**DOCUMENT 00 90 00
ADDENDUM**

ADDENDUM NO. [1] Date: August 14, 2019

**RE: LANESBORO PUBLIC SCHOOLS
 ADDITION AND REMODEL
 100 KIRKWOOD ST EAST
 LANESBORO, MN 55949
 HSR 18063**

**FROM: HSR Associates, Inc
 100 Milwaukee Street
 La Crosse, WI 54603
 (608) 784-1830**

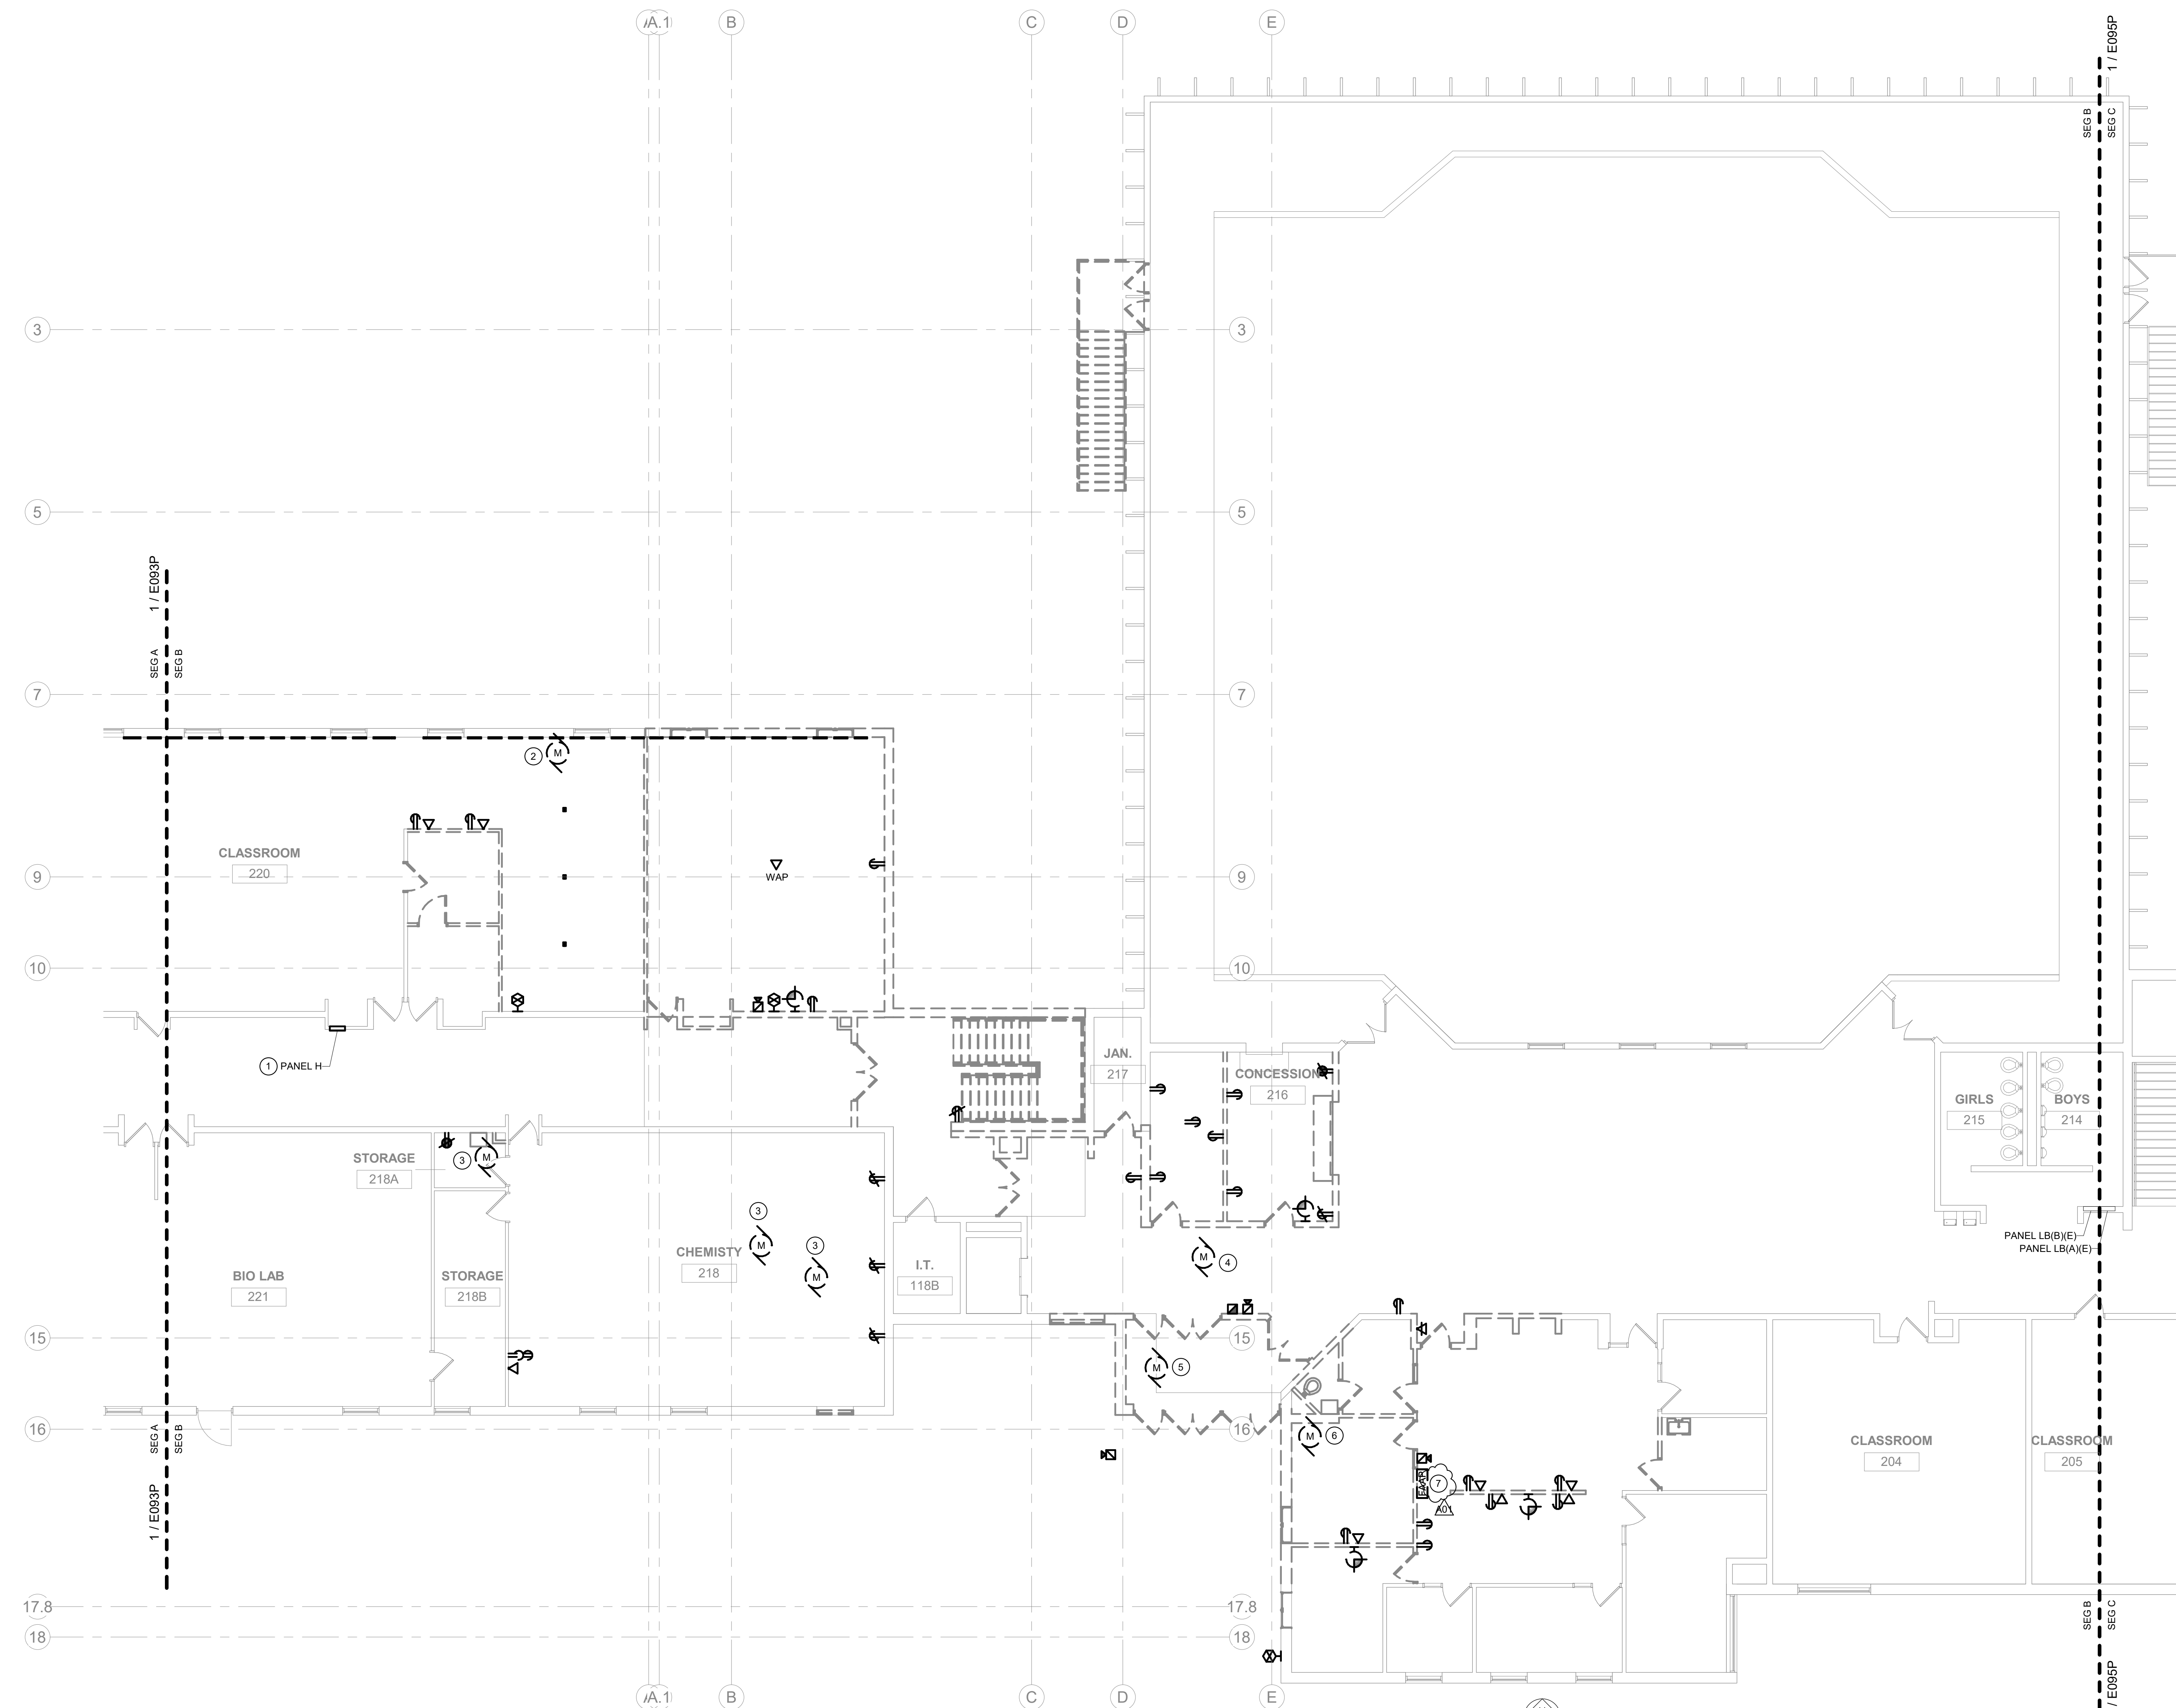
47. Sheet E094P UPPER LEVEL DEMO - SEG B - POWER/SYSTEMS 30 x 42 attached hereto
 - a. Revisions clouded on Drawing.
 - b. Add keyed note seven to clarify demolition work for fire alarm annunciator panel, as shown.

E100P

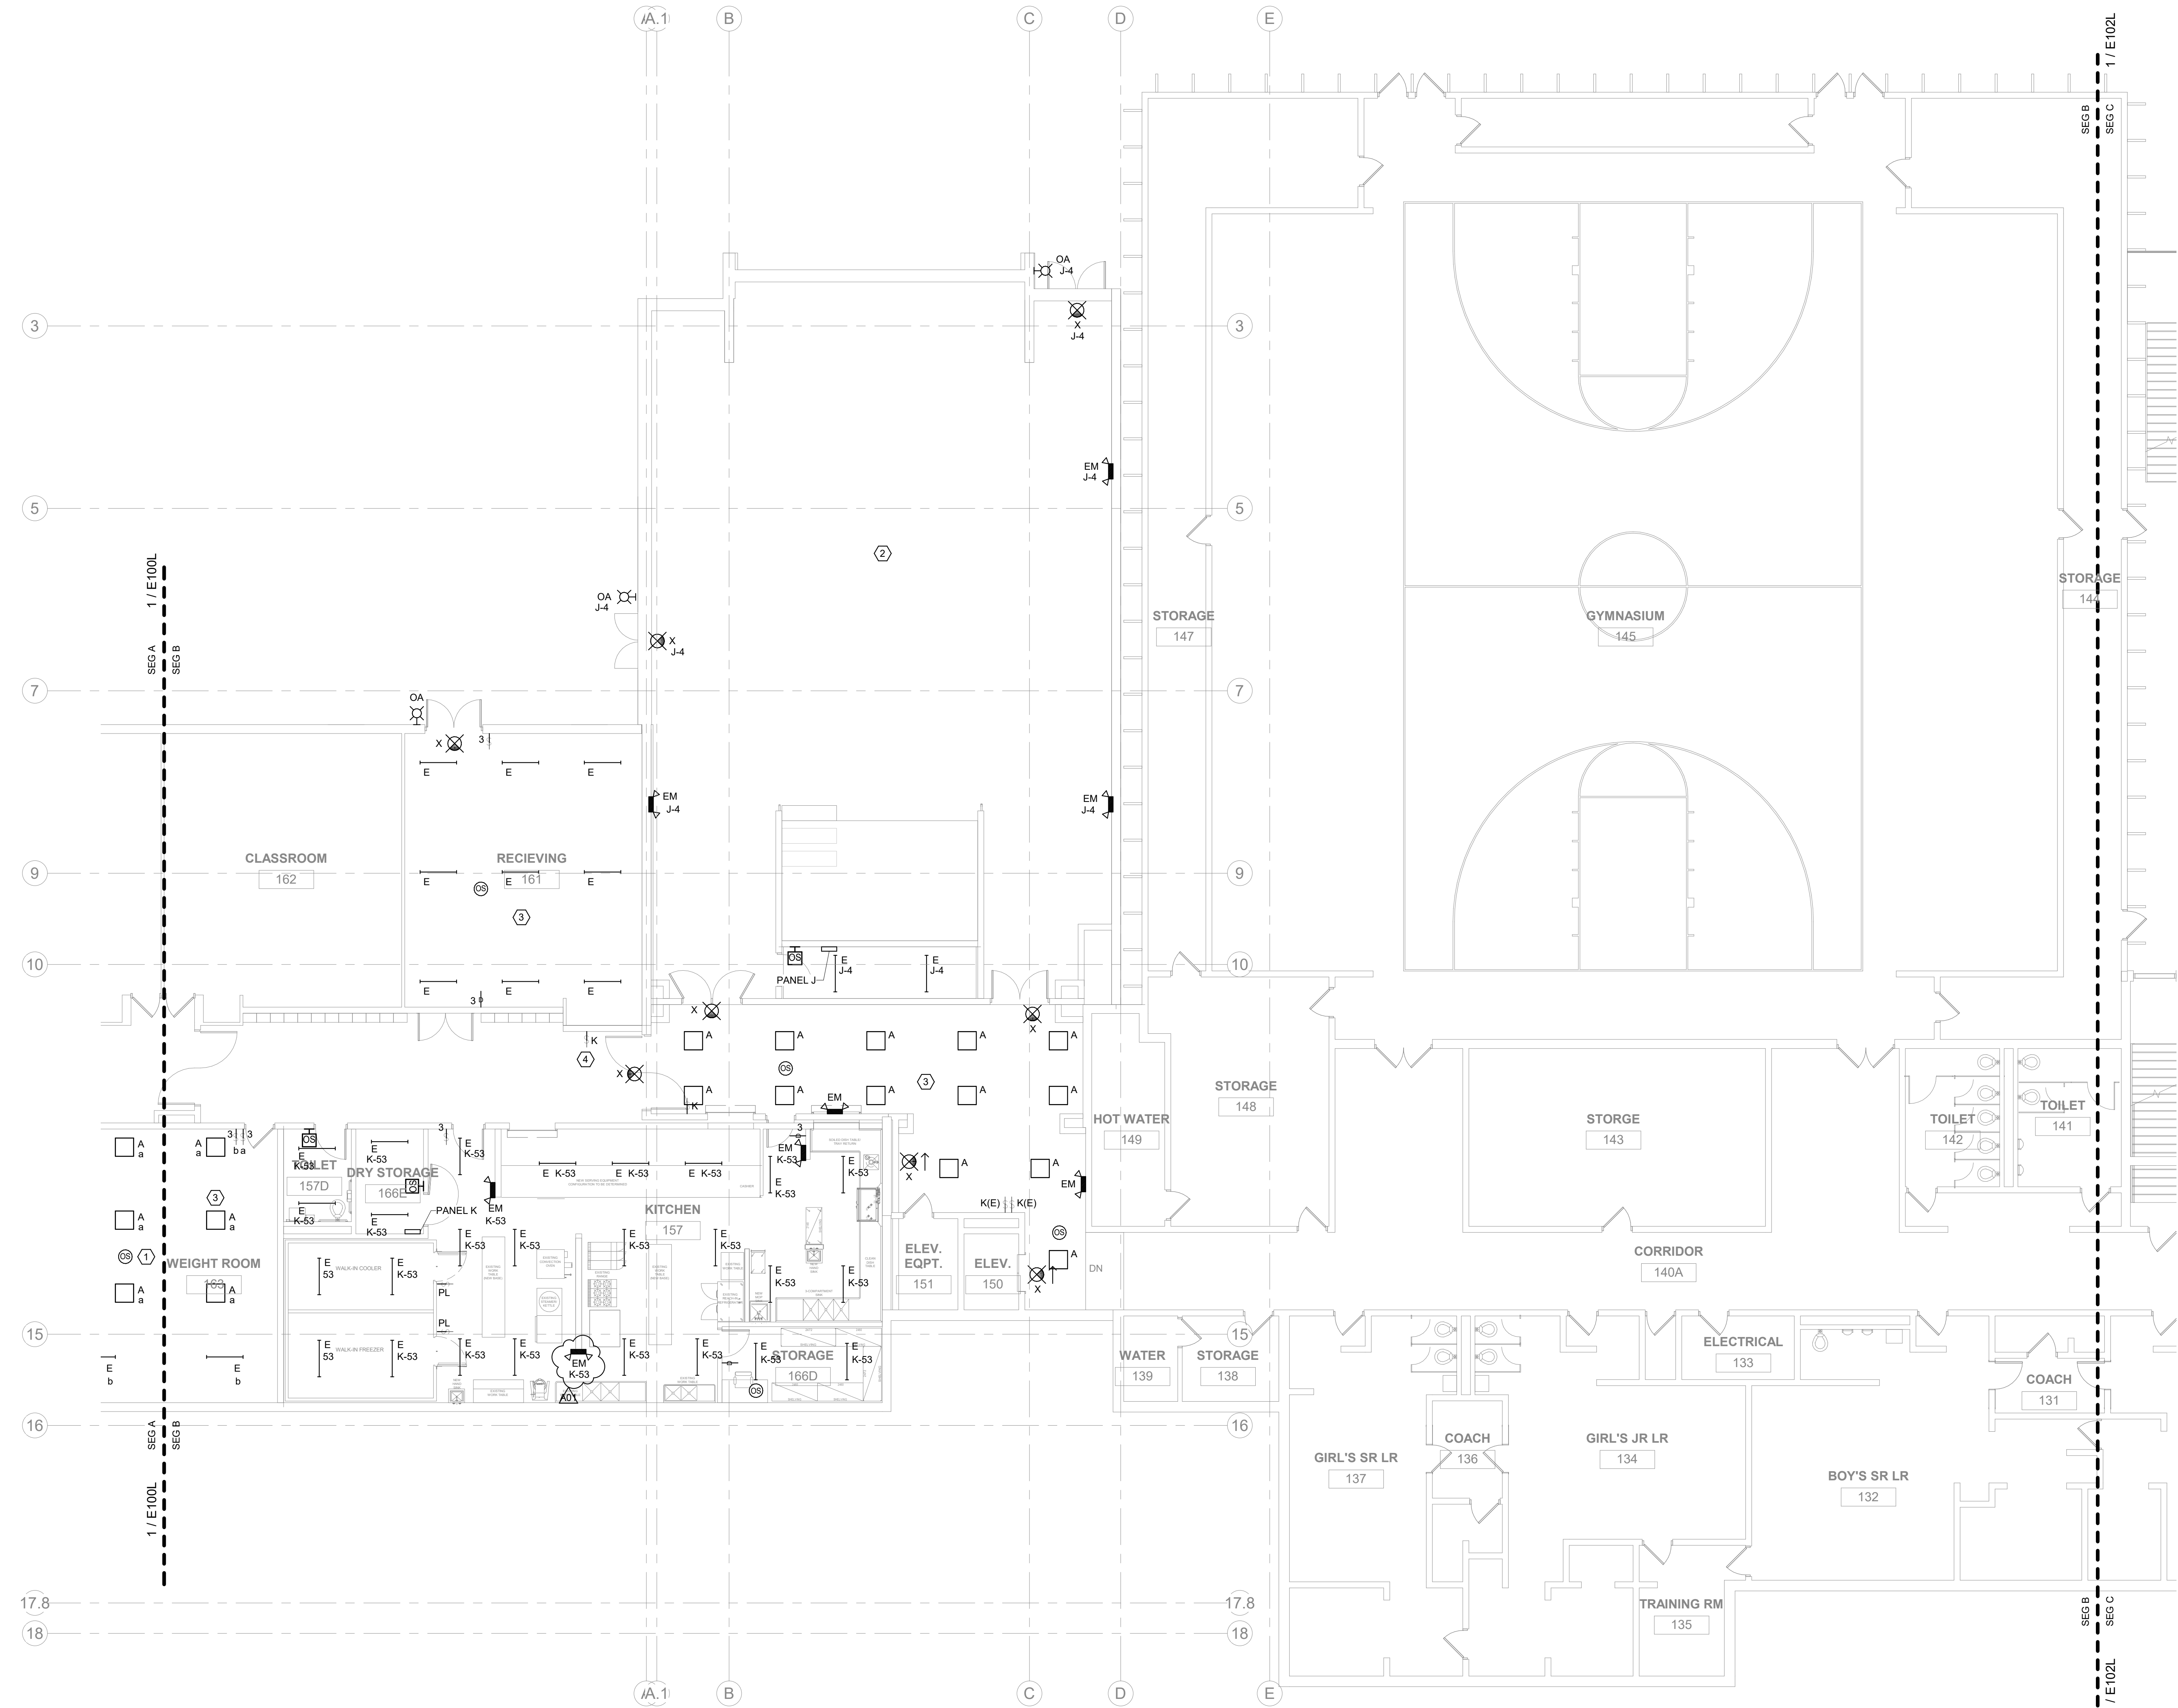
- c. Remove unused space tags, as shown.
 - d. Revise Panel D location, as shown.
49. Sheet E100P LOWER LEVEL – SEGMENT A – POWER/SYSTEMS 30 x 42 attached hereto

- a. Revisions clouded on Drawing.
 - b. Revise Panel D location, as shown.
50. Sheet E101L LOWER LEVEL – SEGMENT B – LIGHTING 30 x 42 attached hereto
 - a. Revisions clouded on Drawing.

E101L

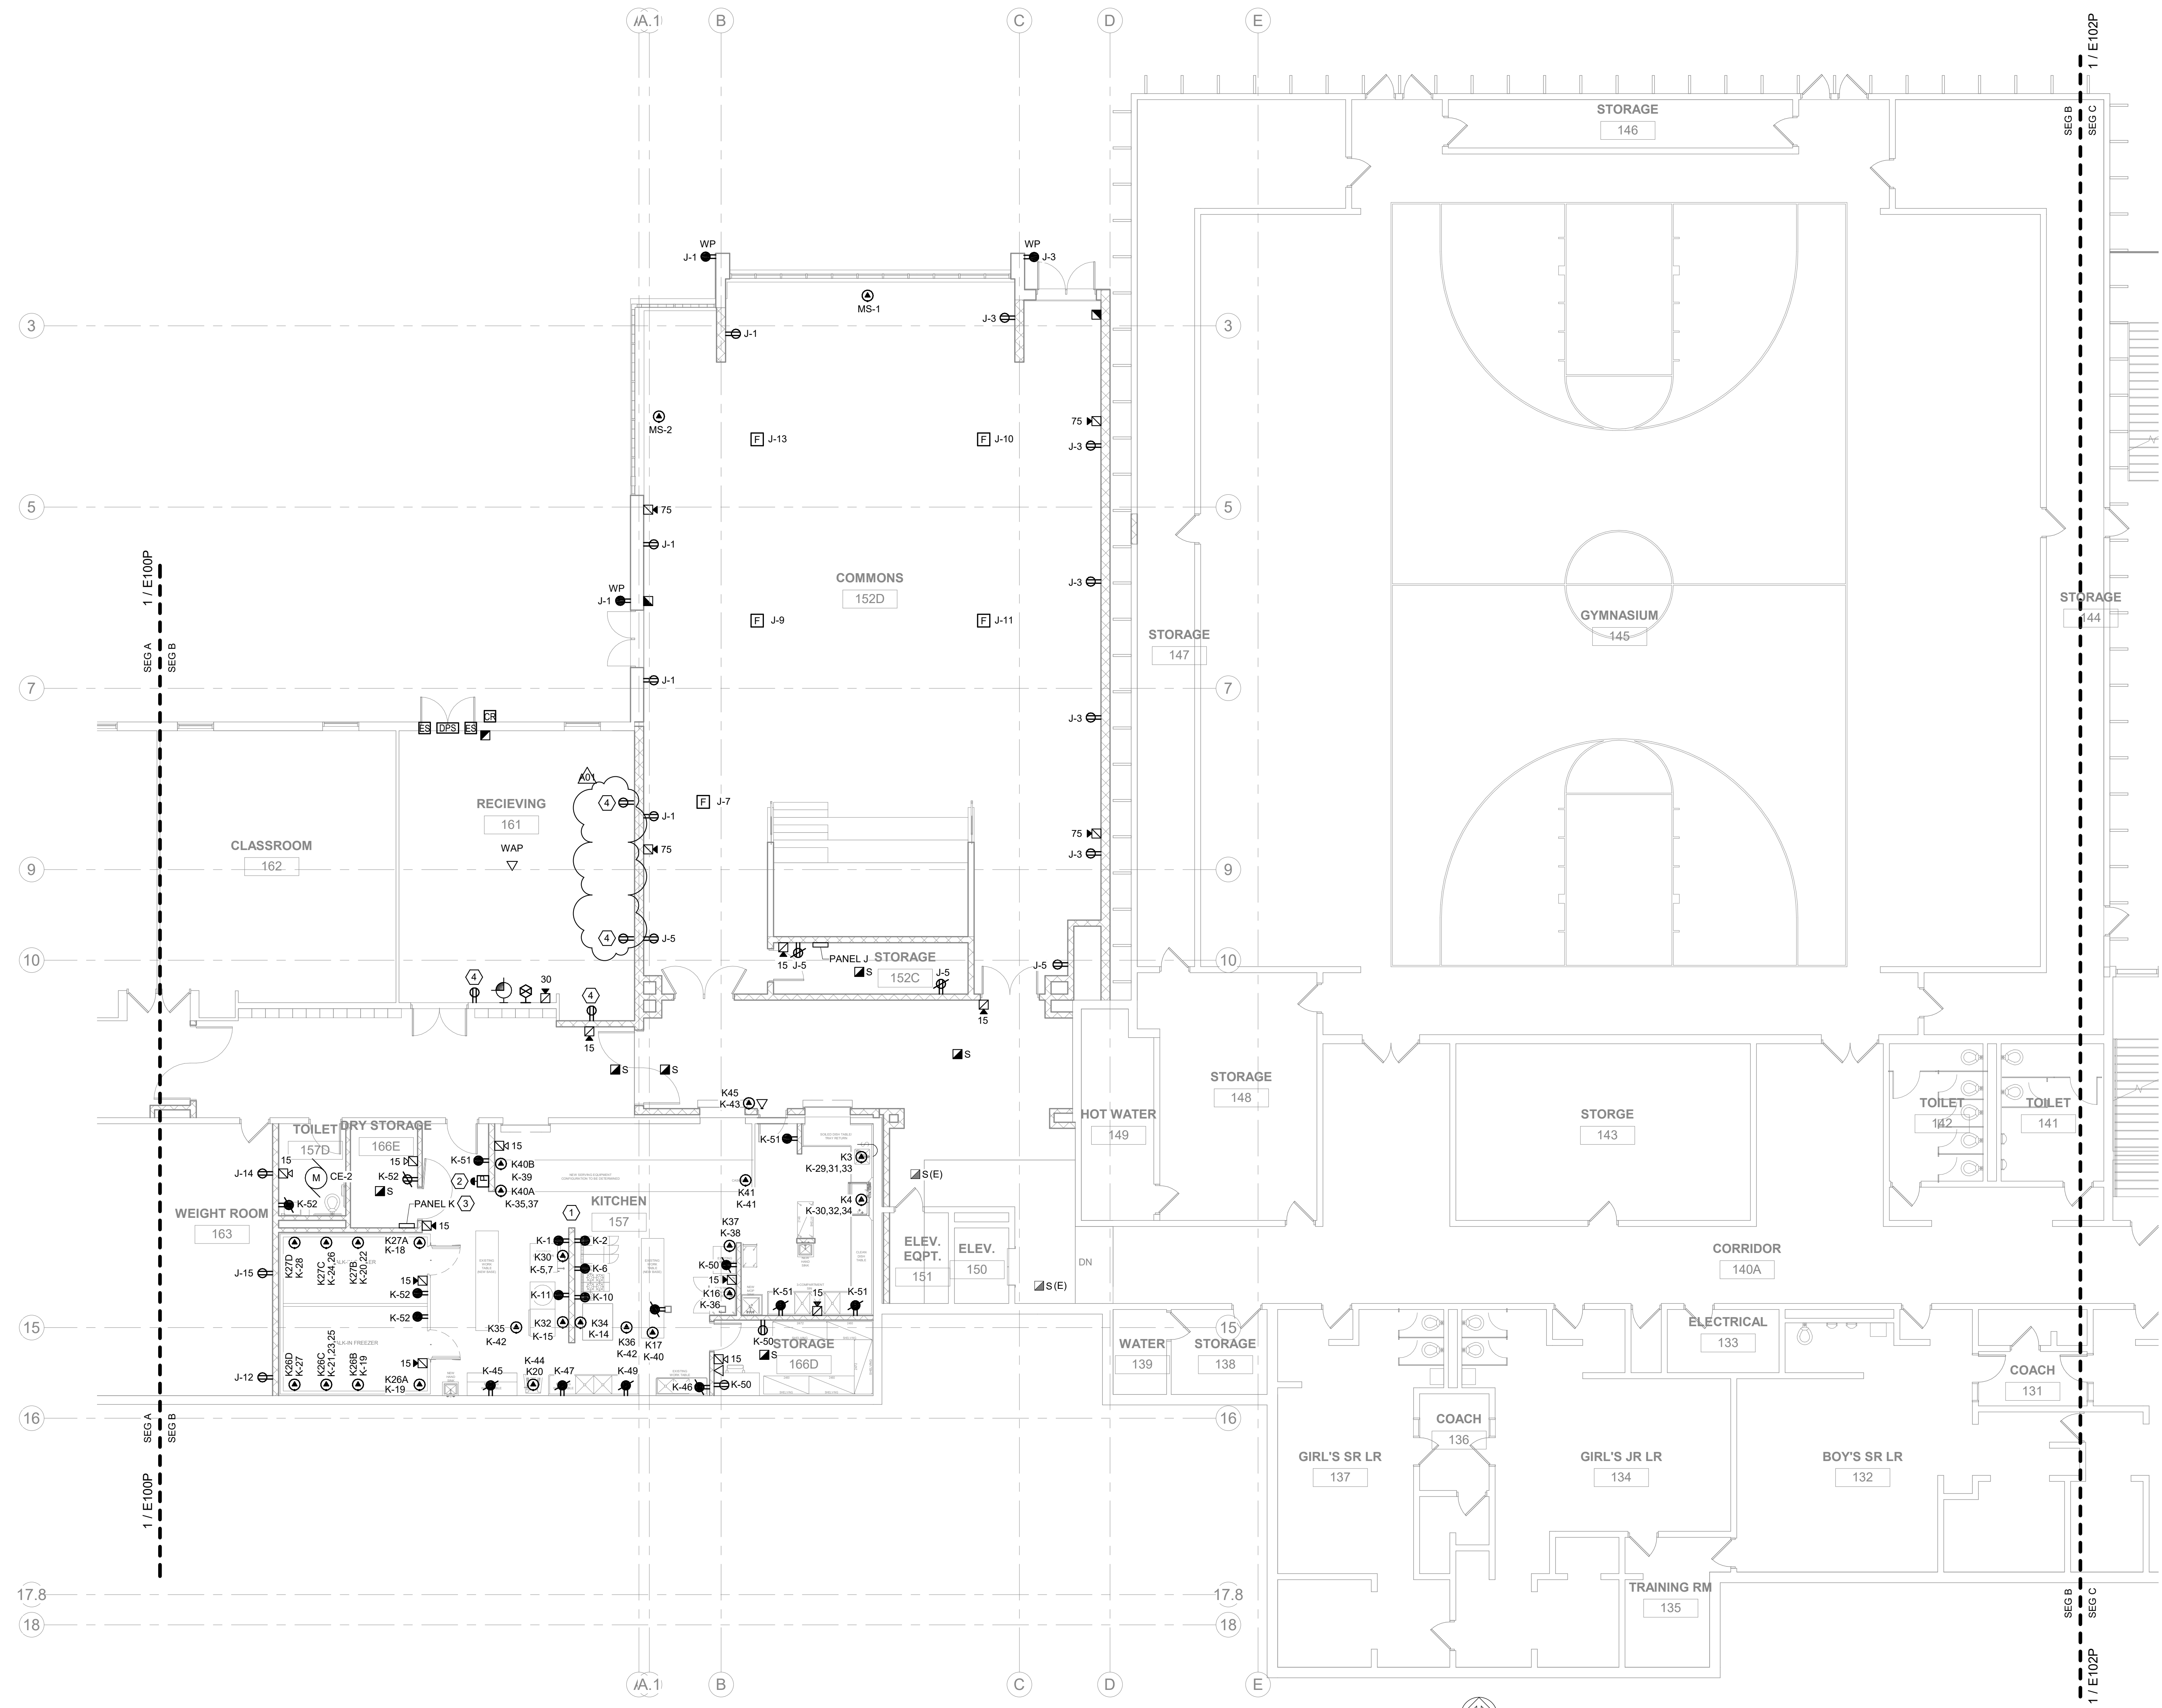
- b. Revise general lighting notes, as shown.
 - c. Add one (1) type EM fixture, as shown.
51. Sheet E101P LOWER LEVEL – SEGMENT B – POWER/SYSTEMS 30 x 42 attached hereto
